SITE PLAN REVIEW DRAWINGS: FOR JONES DAIRY STORAGE FACILITY

1200 JONES DAIRY RD ROLESVILLE, NC 27587

SITE PLAN#: SDP-23-03 REZONING CASE #: MA-22-09 TEXT AMENDMENT CASE #: TA-22-02

JOB NO. 54832
 SHEET NO. C-32

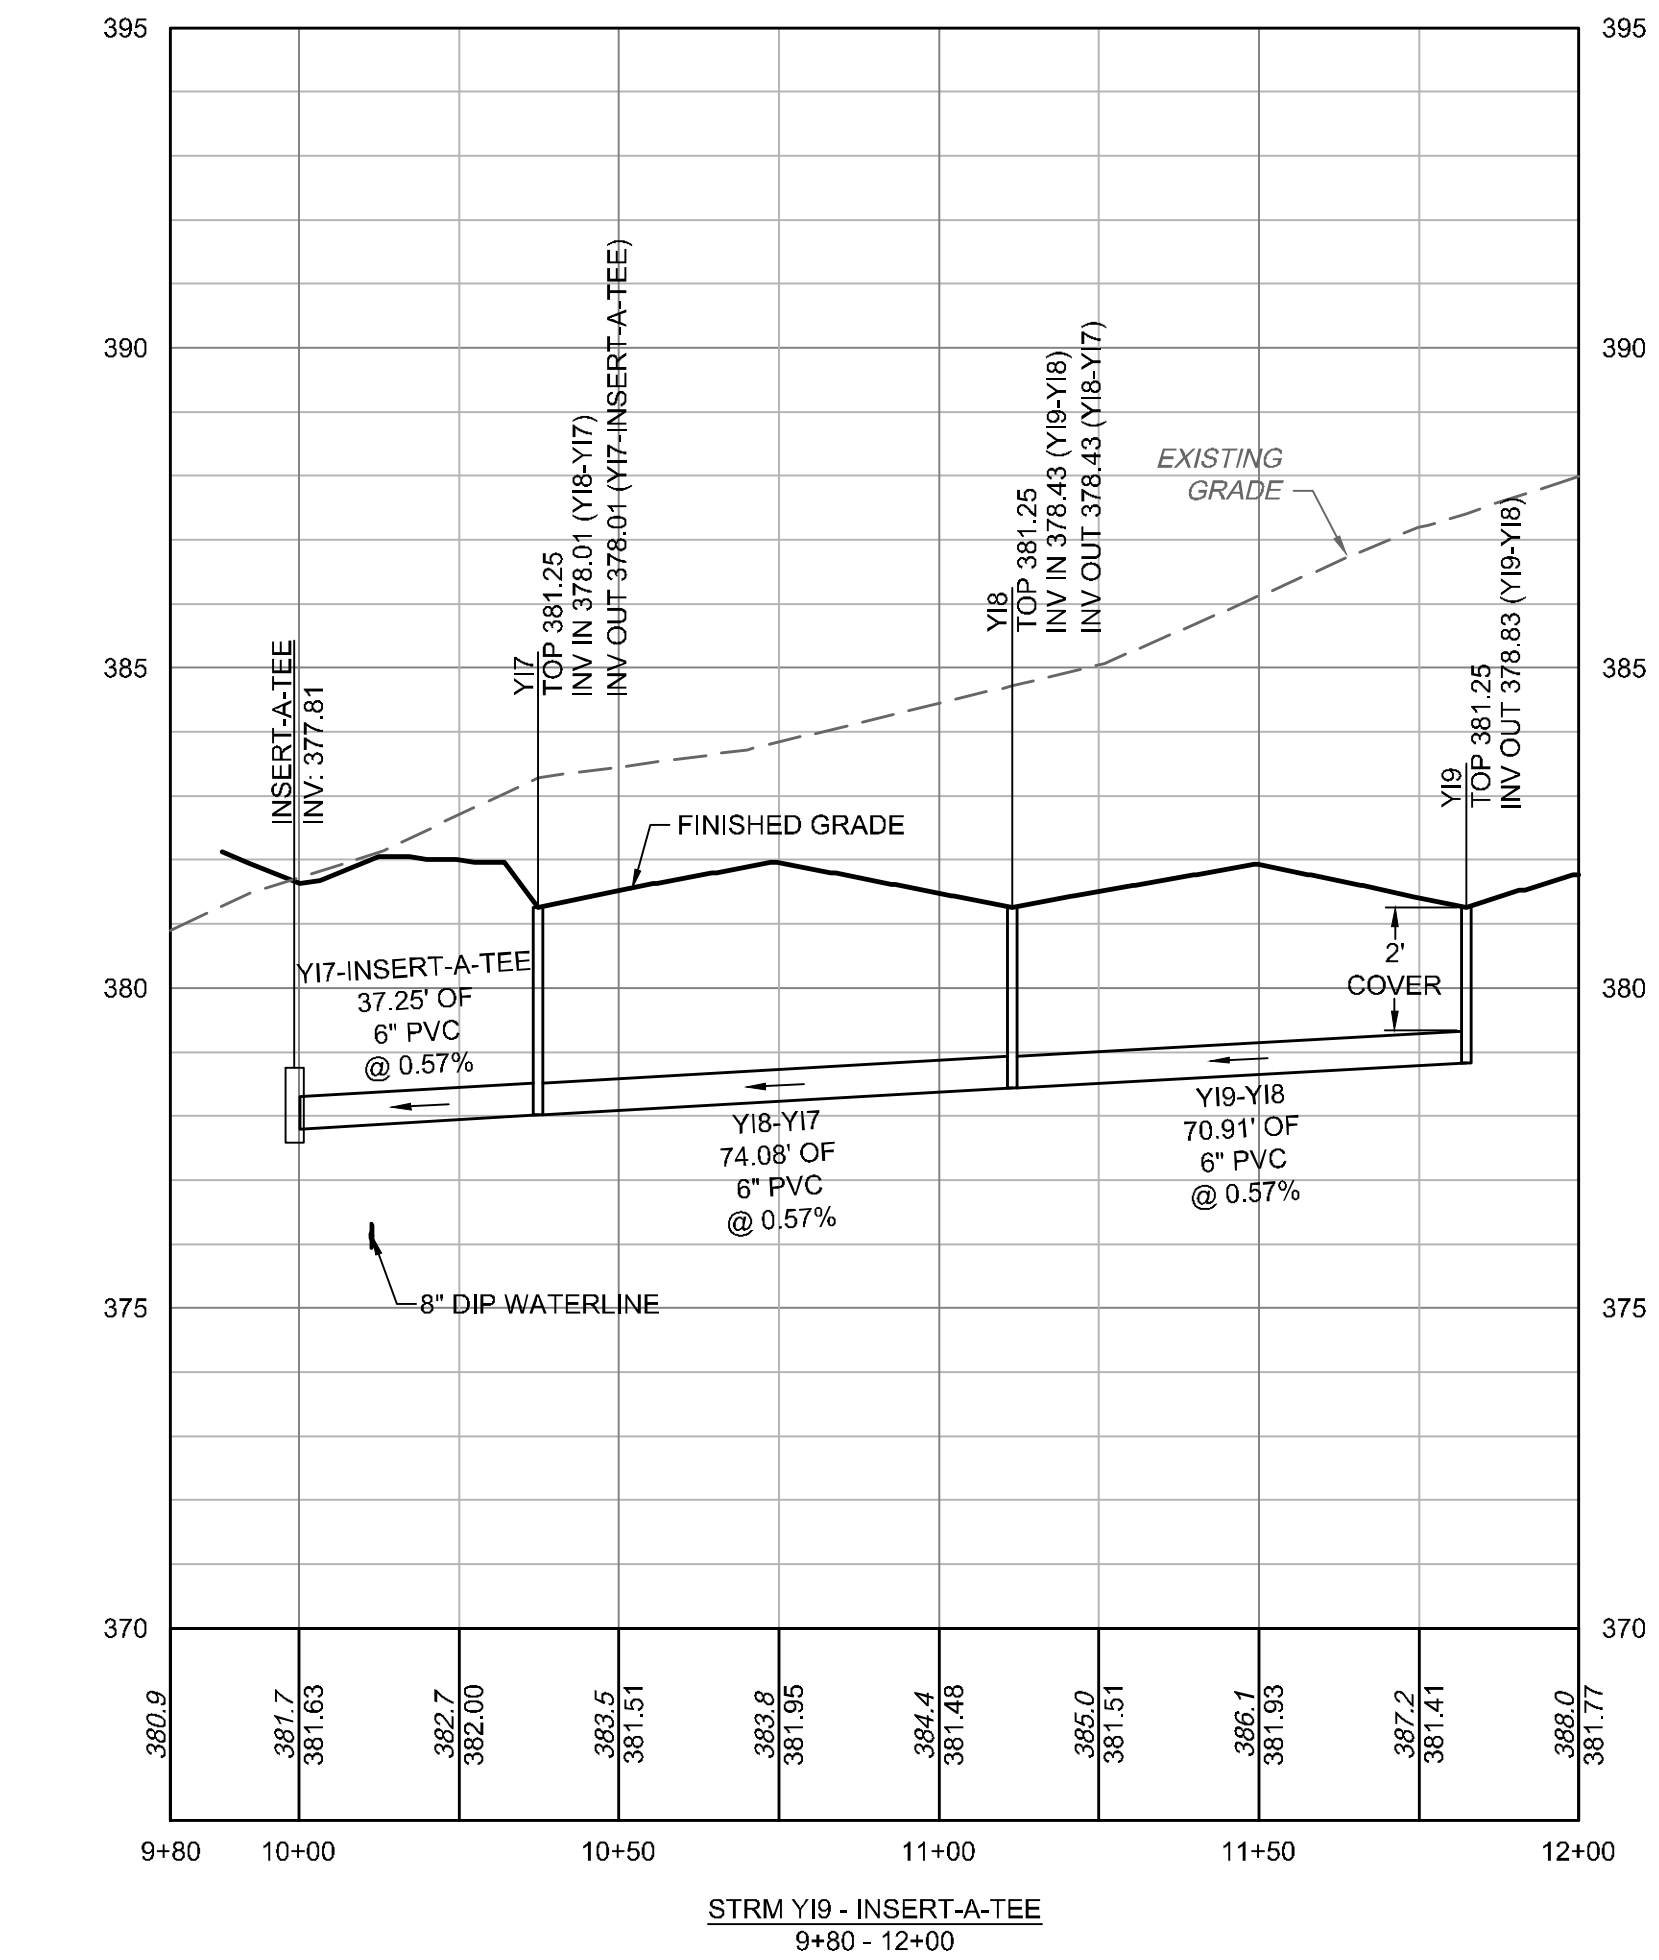
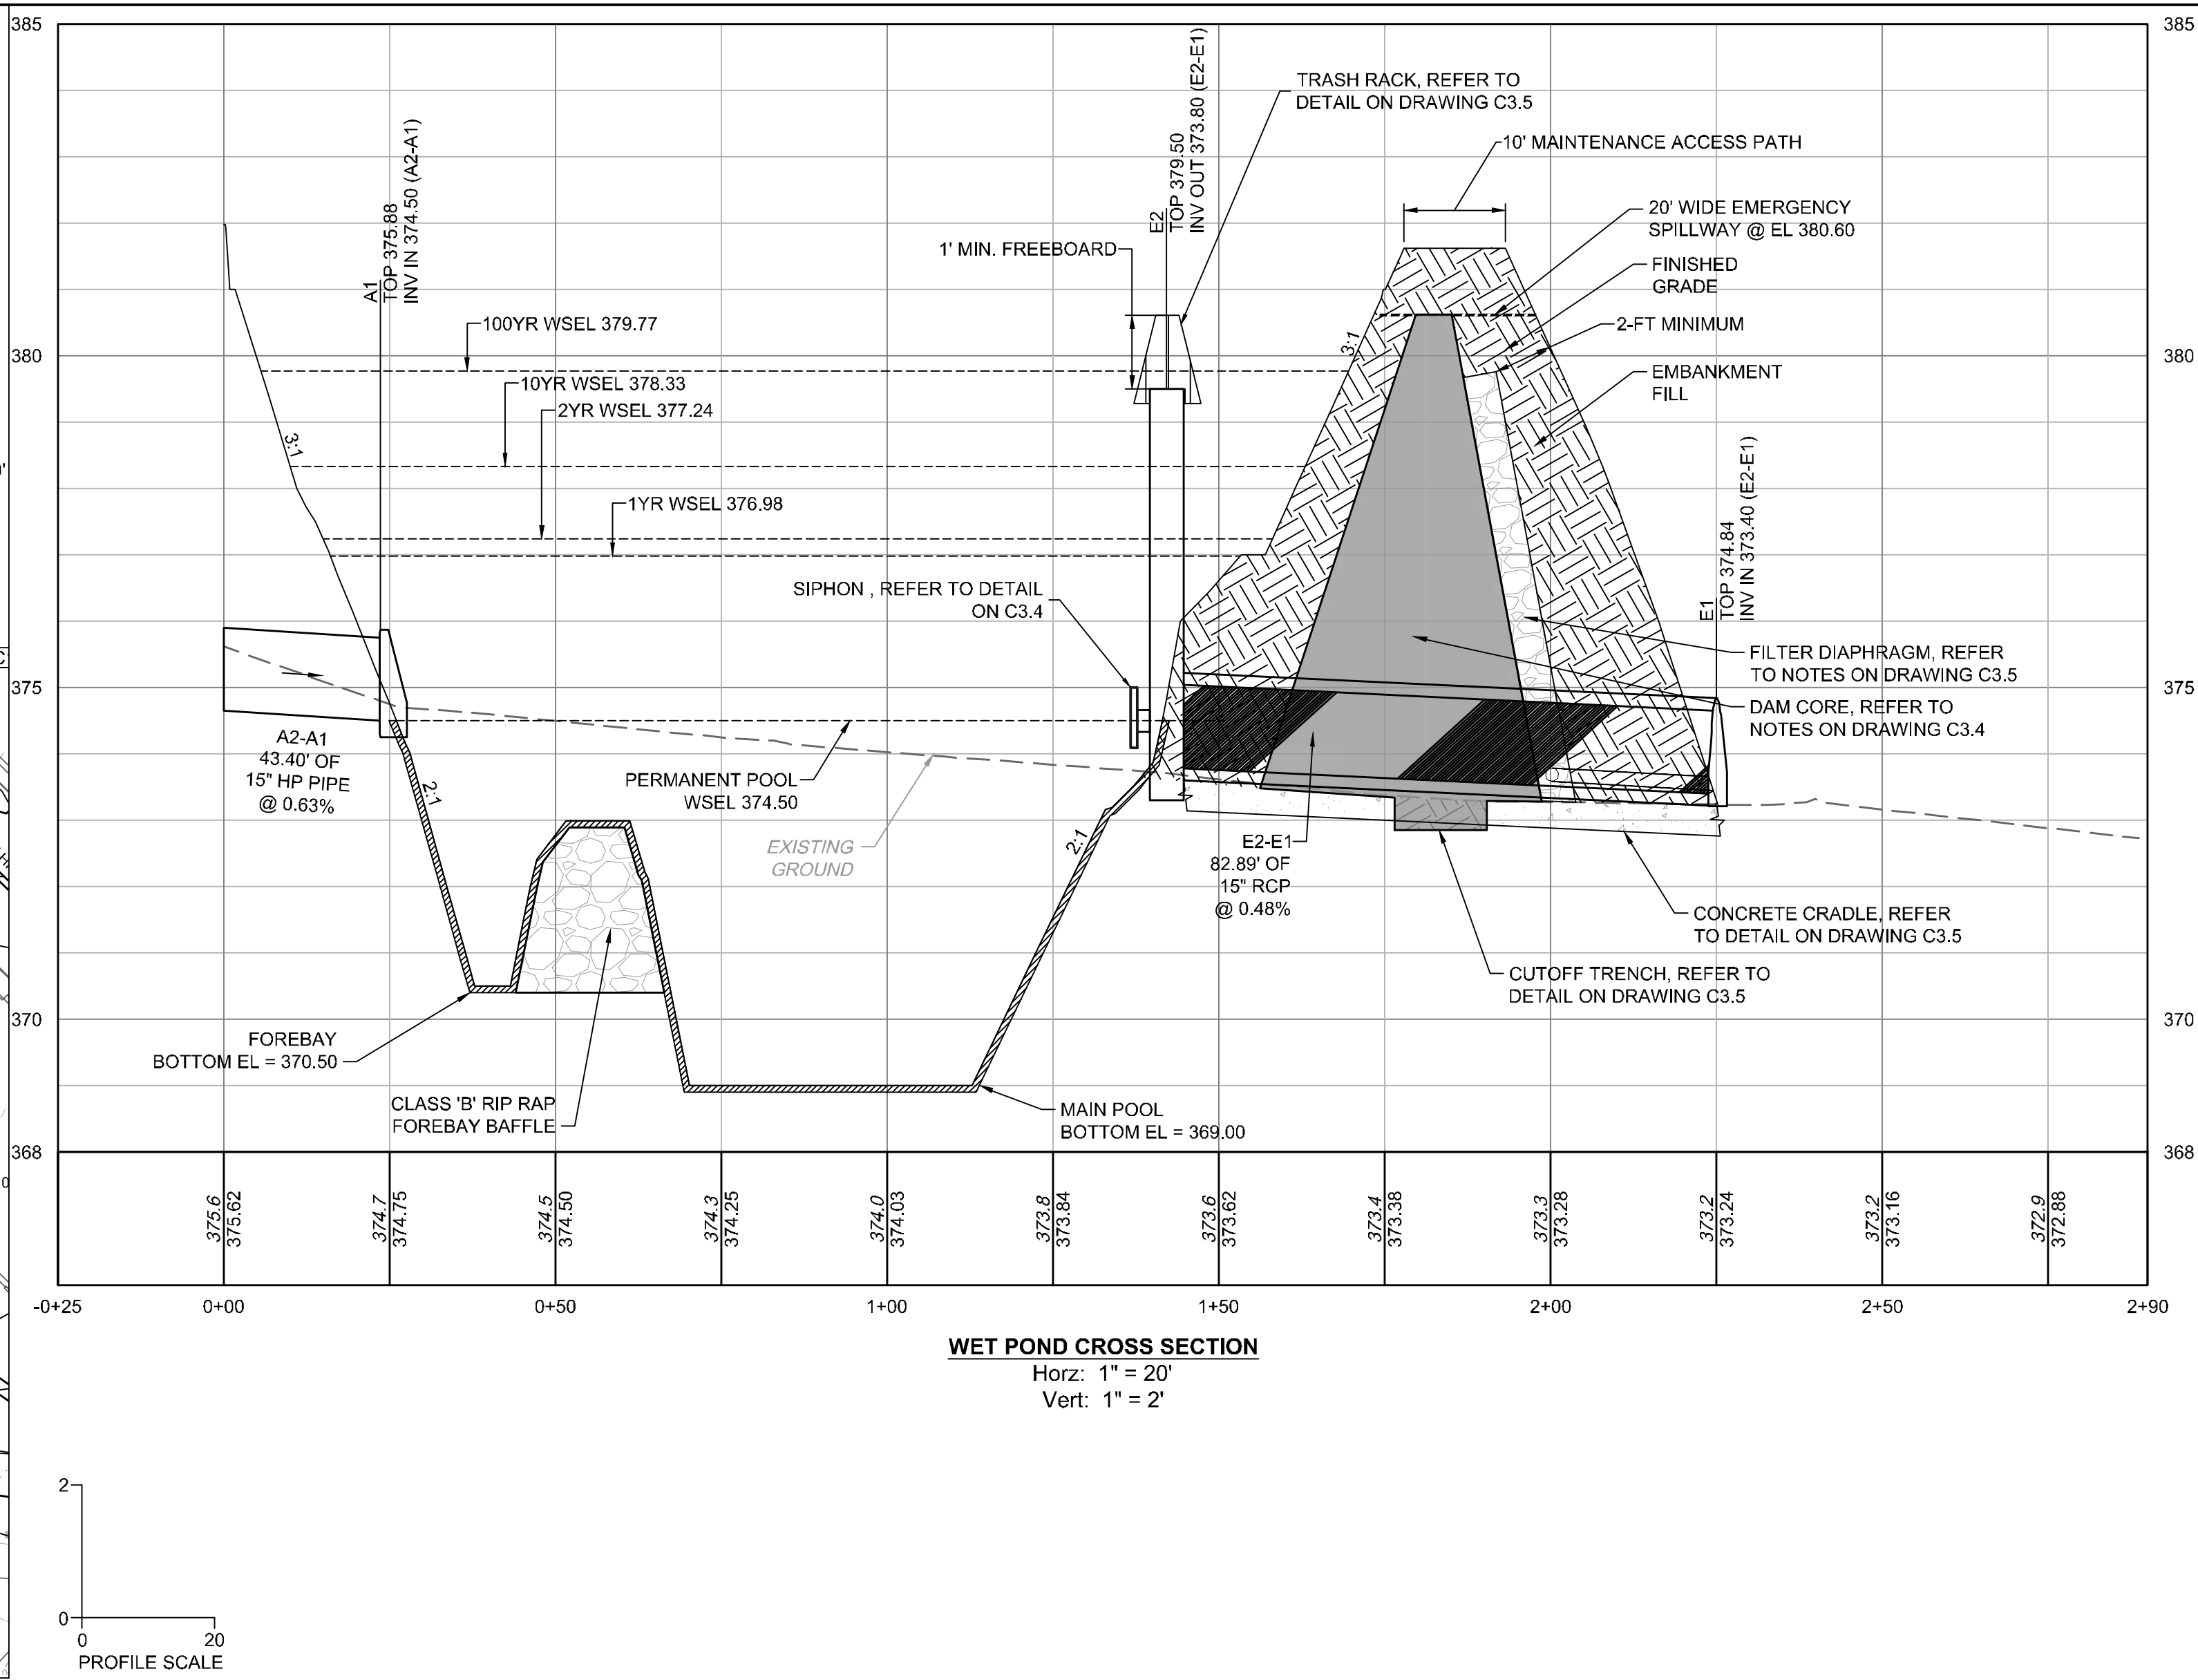
#3 - Doesn't have minimum cover; please revise

#6 - REPEAT: Label separation requirements on ALL profiles

#5 - Sheet number is duplicated
